**Addendum No. 07**

**Subject:** Edward Gideon School  
SDP Contract No. B-055C OF 2018/19

**Location:** Edward Gideon School  
2817 West Glenwood Ave.  
Philadelphia, PA 19121

**This Addendum, dated January 21<sup>st</sup>, 2021 shall modify and become part of the Contract Documents for the work of this project. Any items not mentioned herein, or affected by, shall be performed strictly in accordance with the original documents.**

**1 ELECTRICAL SITE PLAN**  
ESP1.0 SCALE: 1/16"=1'-0"

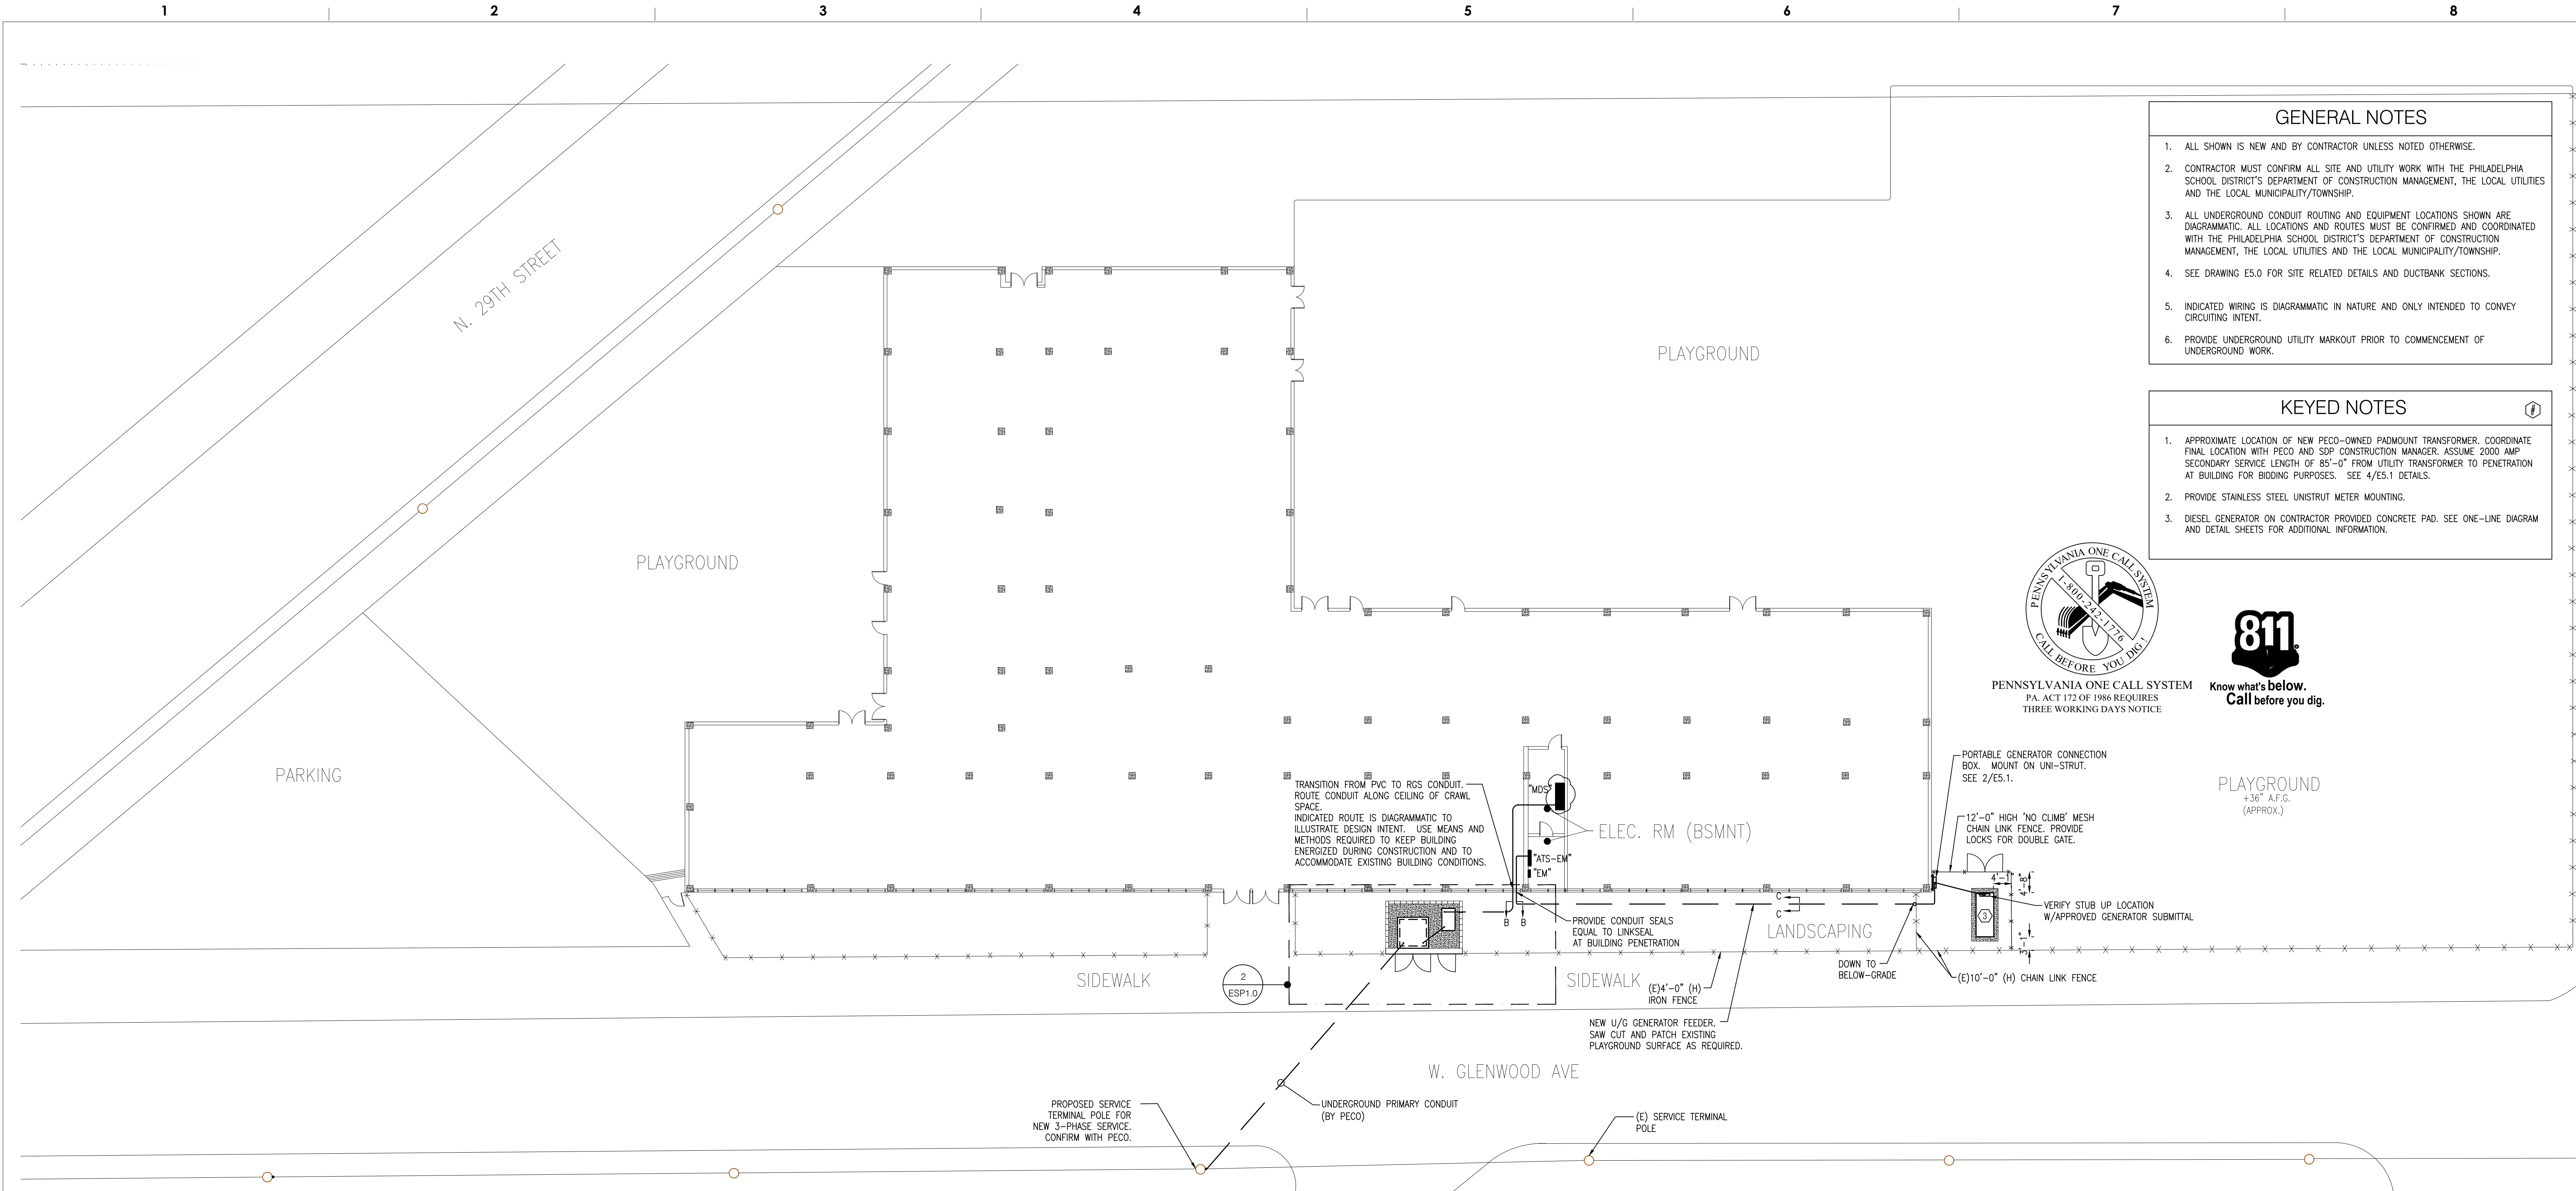
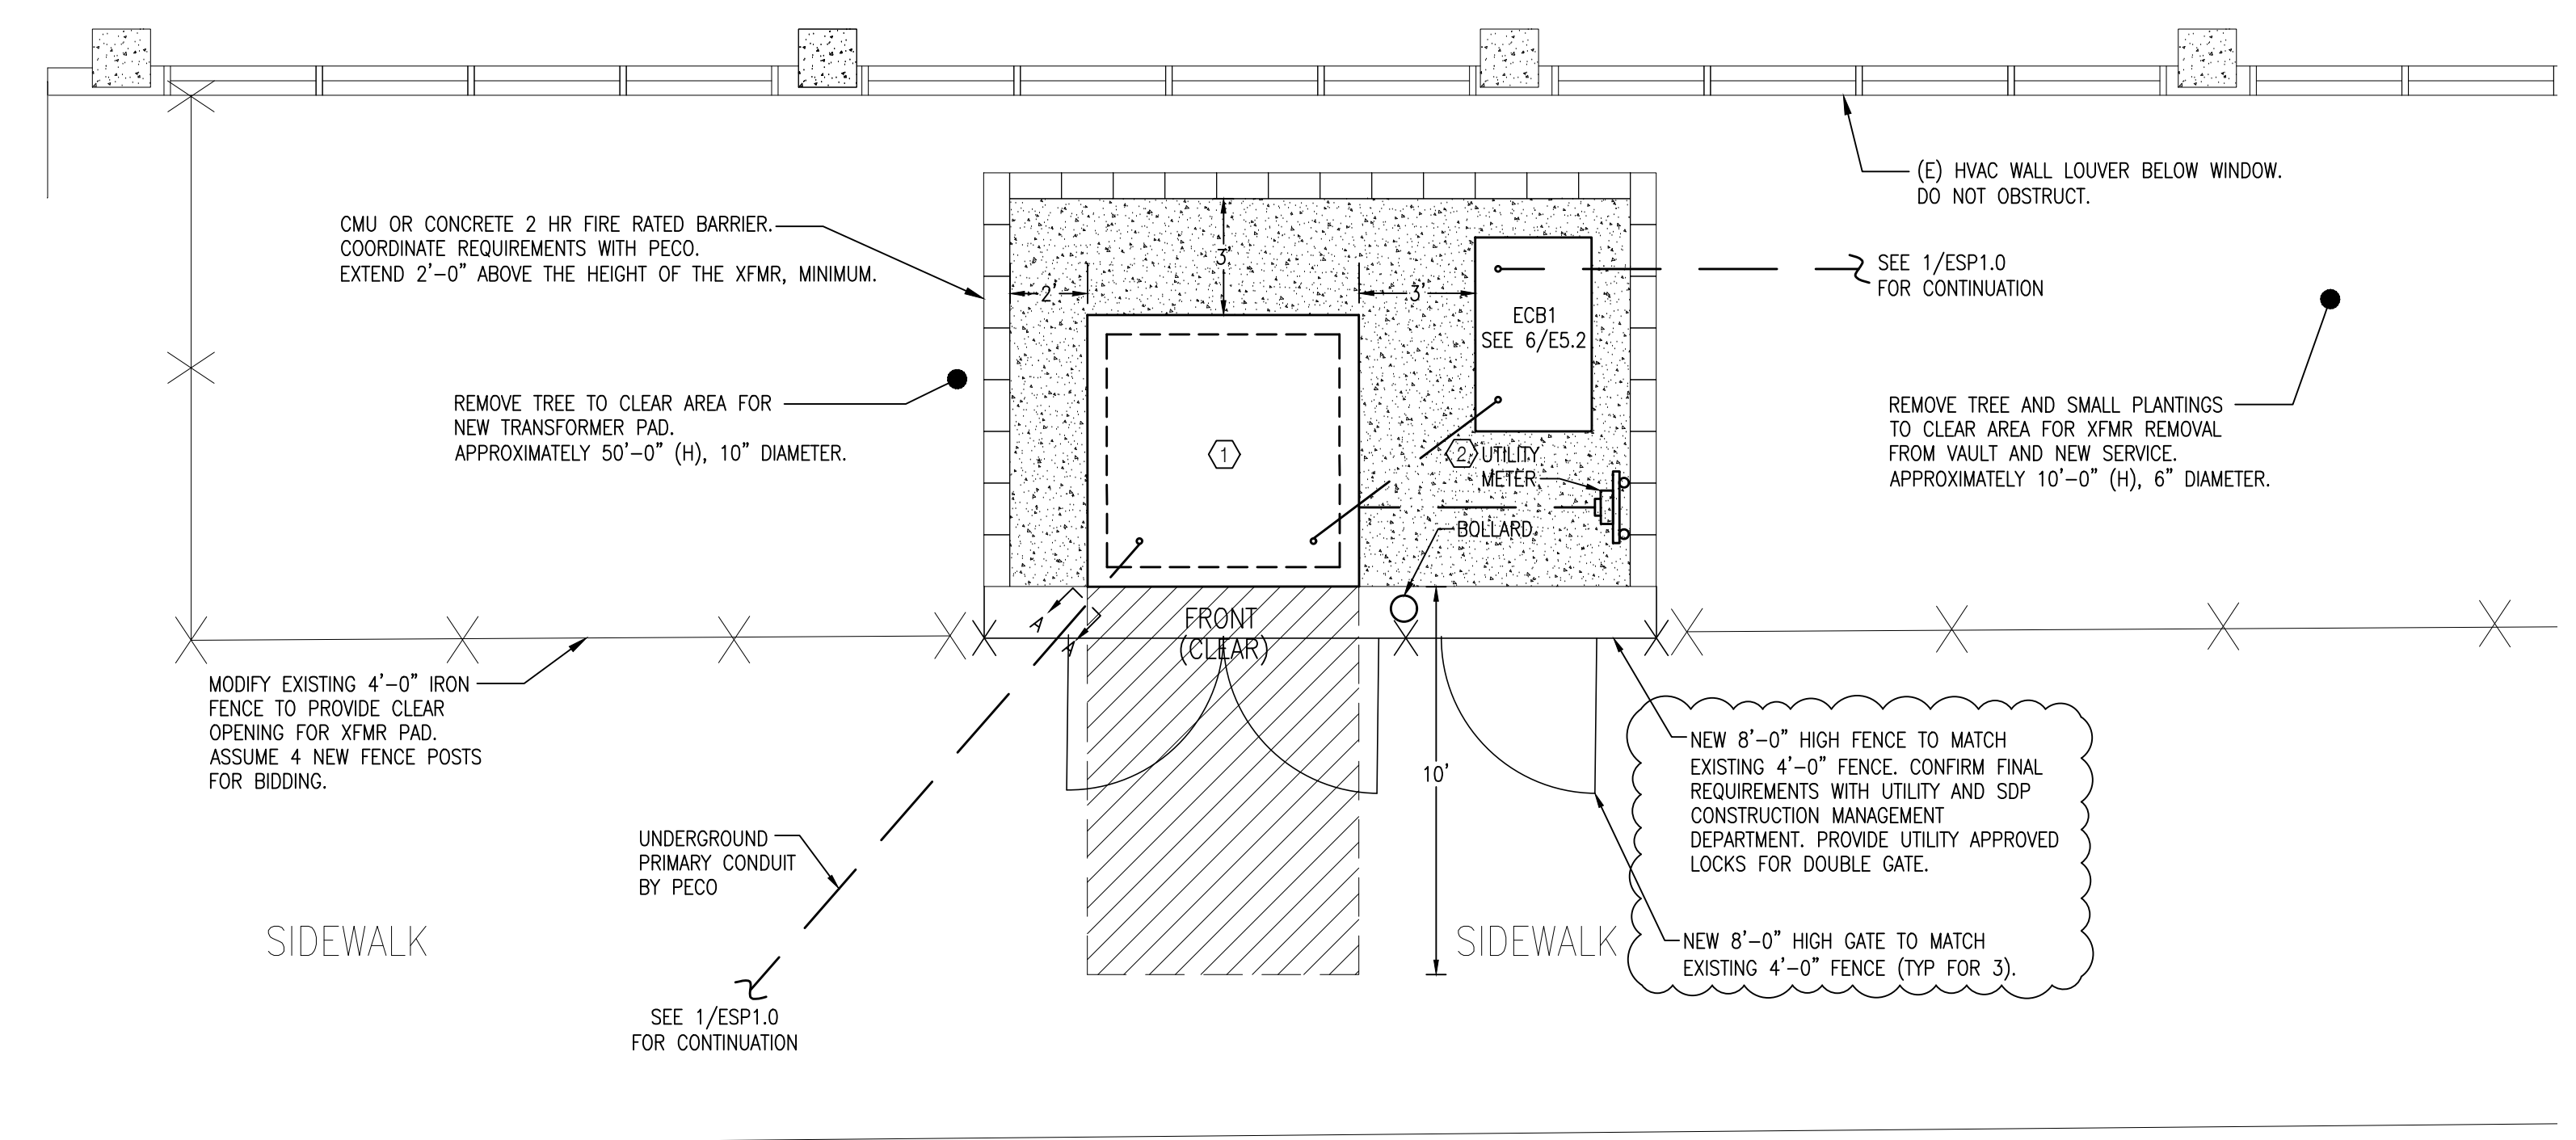
ESP1.0 Site Plan: Revised fence and gates.  
E2.3 Electrical Lighting Plan – Third Floor: Revised Gym lights and controls.  
E3.0 Electrical Power Plan – Basement: Revised switchboard MDS location.
